MEMORANDUM

FROM: Andrew Sampsell, PE - Dam Safety Program - Engineer

SUBJECT: Risk Reduction Measures
Prison Pond Dam, Windsor, Vermont
State ID No. 248.07
National ID No. VT00363

Crest images

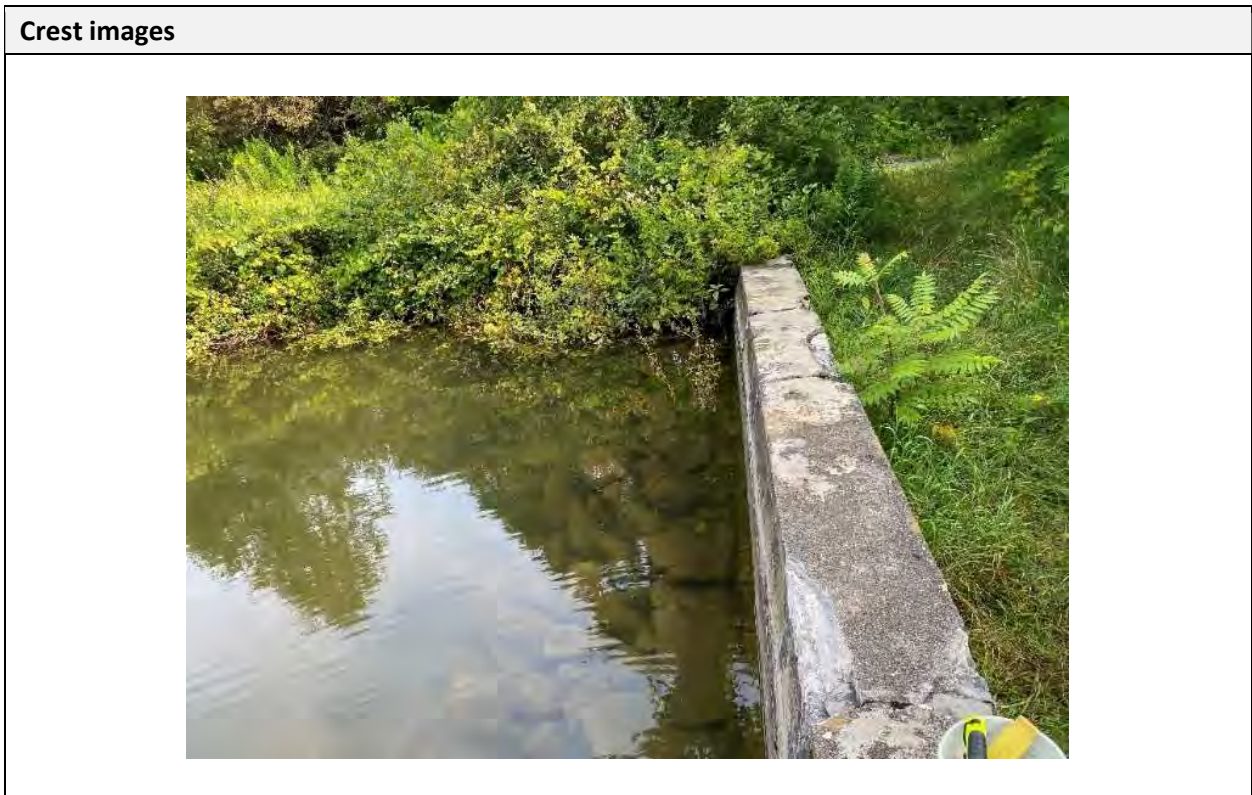
Crest	
Length: 154 ft	Width: 1.5 ft
Freeboard: Principal spillway crest to dam crest: 2.3 ft	
Additional comments: It is unknown how far down the crest wall extends into the embankment. At the left abutment a concrete wing-wall extends upstream towards the impoundment. Reportedly this wingwall was installed to prevent the adjacent access road from being washed-out during rare flood events. Several joints along the top of the crest wall are deteriorating and missing material. There is evidence of past repairs made to address concrete spalling along the crest of the wall.

Crest issues	Action
Brush Coverage: Dense Location: Right End, Middle	<input type="checkbox"/> None <input type="checkbox"/> Monitor <input checked="" type="checkbox"/> Maintenance <input type="checkbox"/> Engineer
Missing Joint Material/Expansion of Joints Location: Entire Surface	<input type="checkbox"/> None <input checked="" type="checkbox"/> Monitor <input checked="" type="checkbox"/> Maintenance <input type="checkbox"/> Engineer

Principal spillway images

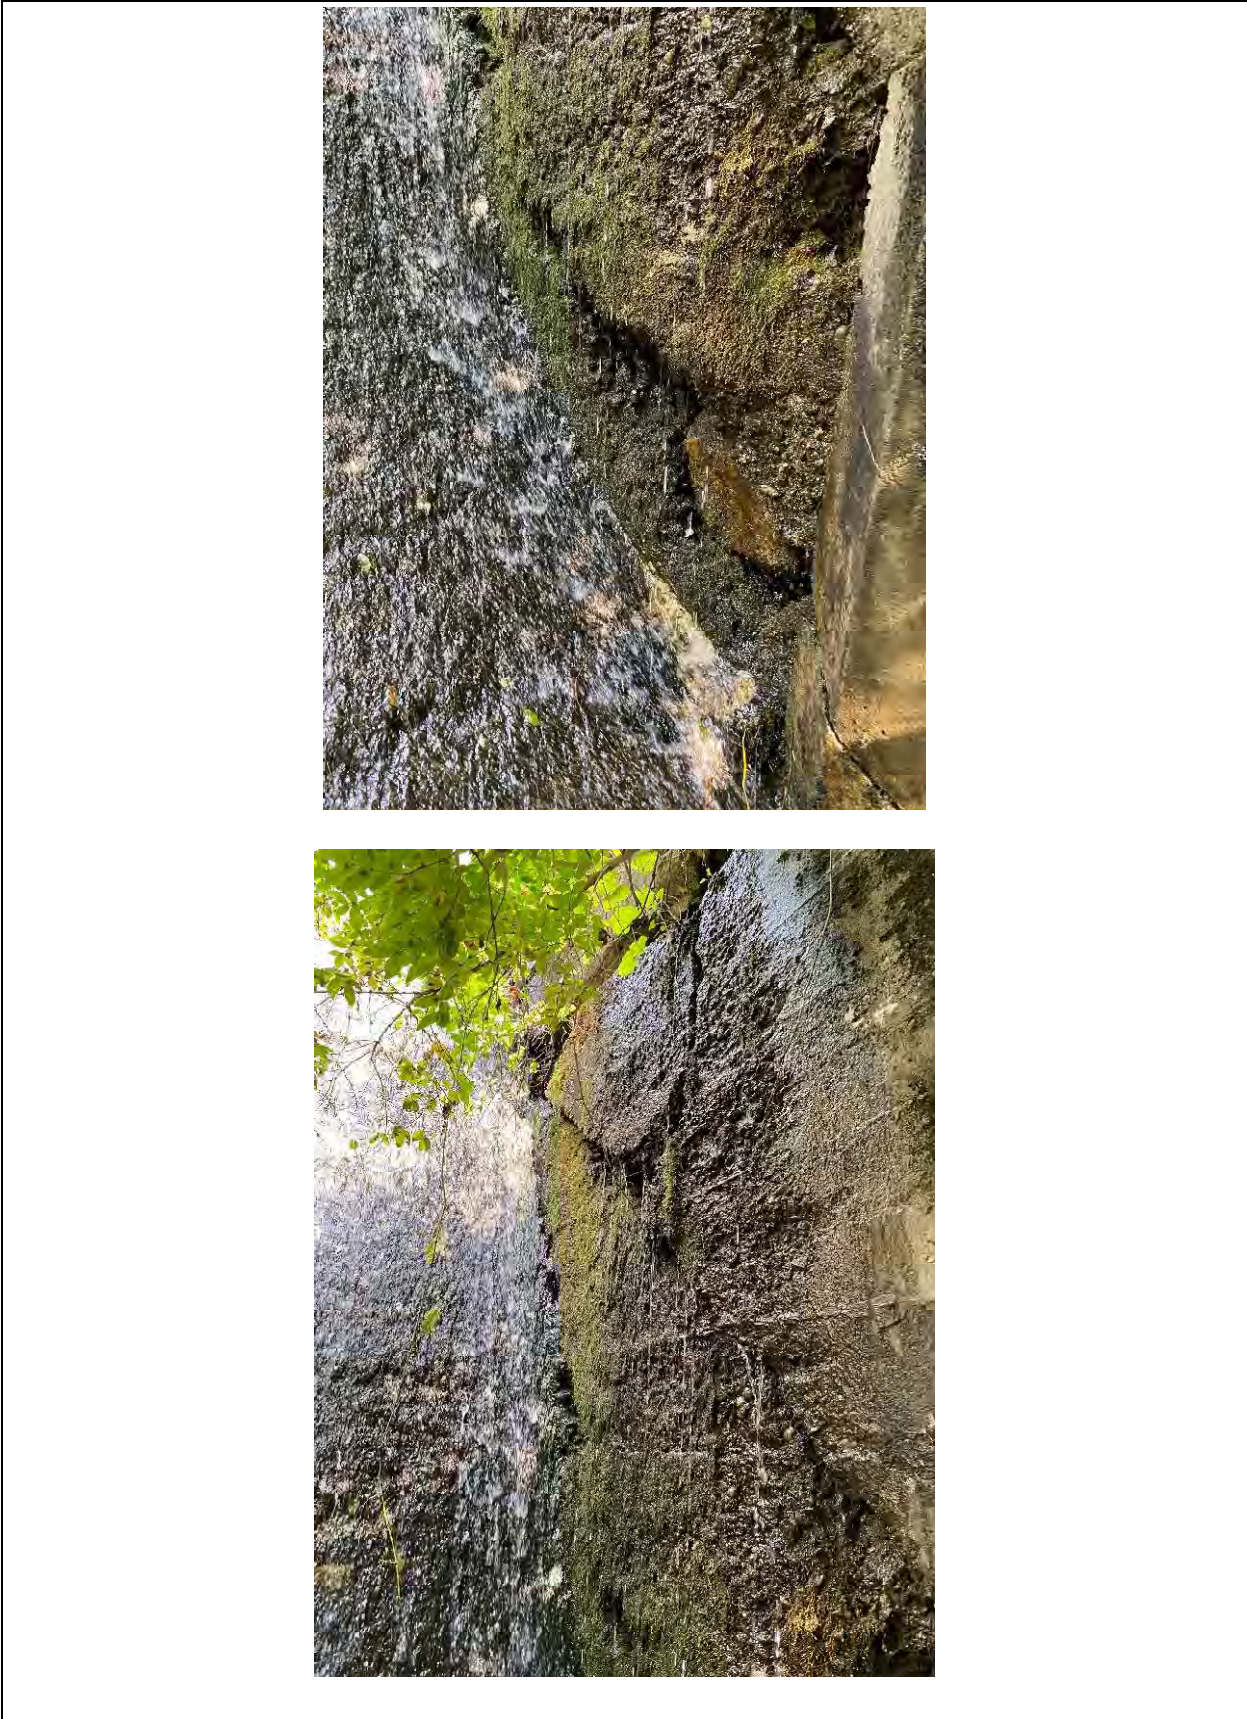
Principal Spillway	
Spillway type: Weir	Primary material: Concrete Weir: Ogee
Spillway location: Center of dam	Gate: Unknown
Water level measured against principal spillway crest: 1-inch above crest	Erosion control structures: Plunge Pool, Impact Basin, Rock-Lined Channel
Spillway components:	
<input type="checkbox"/> Anti-vortex plate	<input type="checkbox"/> Filter Diaphragm <input checked="" type="checkbox"/> Training Walls
<input type="checkbox"/> Flashboard	<input type="checkbox"/> Trash rack <input type="checkbox"/> Other:
<p>Additional comments: Water seeping through dam crest wall is running along the outside of the principal spillway training walls and eroding material. The base of the left concrete spillway training wall is being undermined. The left spillway training wall is more deteriorated than the right wall and has several cracks of considerable size. It appears the right wall was replaced or resurfaced more recently than the left wall. The surface of the spillway chute is slowly being eroded; deterioration is concentrating at vertical lift joints.</p>

Principal spillway issues	Action																
<p>Deteriorating concrete</p> <p>Issues:</p>

<i>Spillways</i>	<ul style="list-style-type: none"> Maintain the spillway free of debris to ensure free-flow conditions. Monitor and repair minor concrete cracking and deterioration. Monitor the condition of the concrete chute and training walls.
